Commercial Components Technical Bulletin

SUBJECT: Replacement of W7212Axxx with W7220A1000 (JADE)	Ref. Number	
	Issue Date	03/20/12
	Author	Adrienne Thomle and Serafima Higginson
Suggested Model Number: W7212	Date Codes Affected: N/A

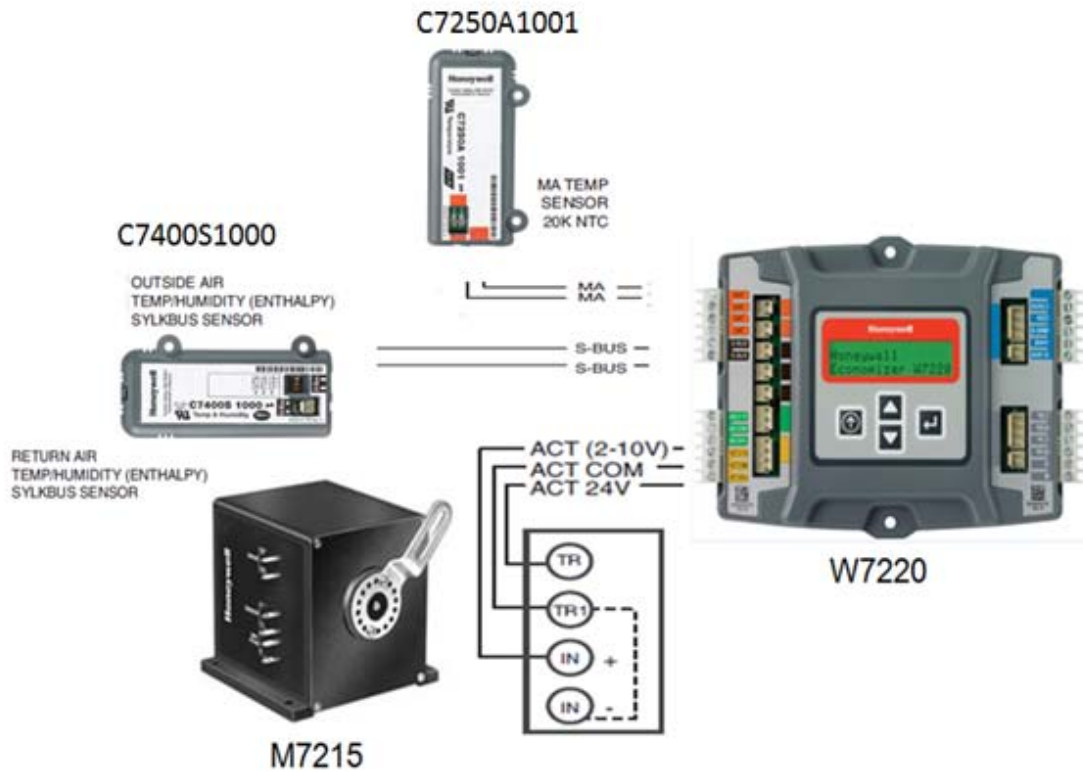
4. Terminate wires removed from the W7212 to the Jade:

W7212 wire termination	W7220 wire termination
1	Y1-In
2	Y1-Out
3	Y2-In
4	Y2-Out
5	NA
TR	R
TR1	C
N	OCC
P-P1	NA
T-T1	MAT*
So-So+	OAT or S-Bus*
Sr-Sr+	S-Bus*
AQ-AQ1	IAQ terminals **
EF-EF1	EFH1***

*Sensor to be changed

** CO2 sensor- no longer requires a separate transformer, can be powered by Jade

*** EFH1 out is 24 Vac, need to add a DPDT relay between EFH1 and C terminals.

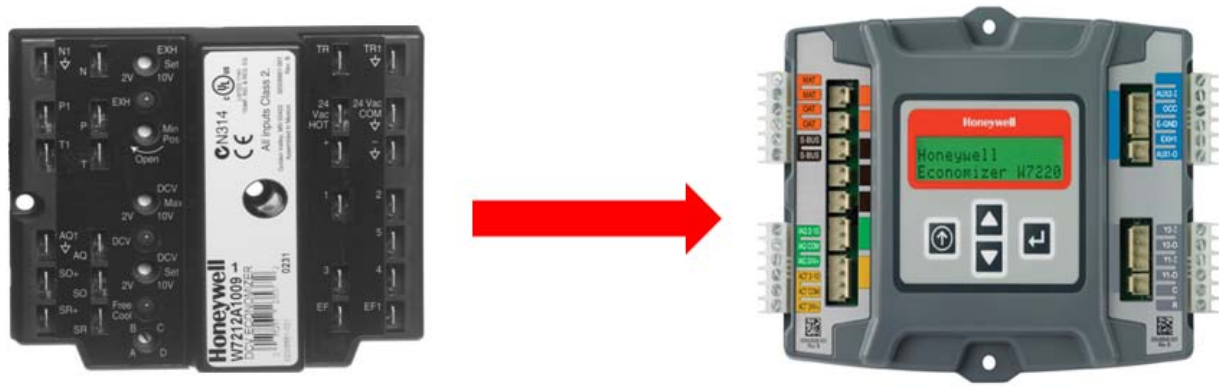
Replace the old sensors with new JADE sensors:

Old Sensor	Description	New Sensor	Termination on W7220
C7046A	Discharge Air	C7400S1000	S-Bus
C7150B	Mixed Air	C7250A1001	MAT
C7400	Solid State Enthalpy	C7400S1000	S-Bus
C7660	Solid State Dry Bulb	C7250A1001	OAT
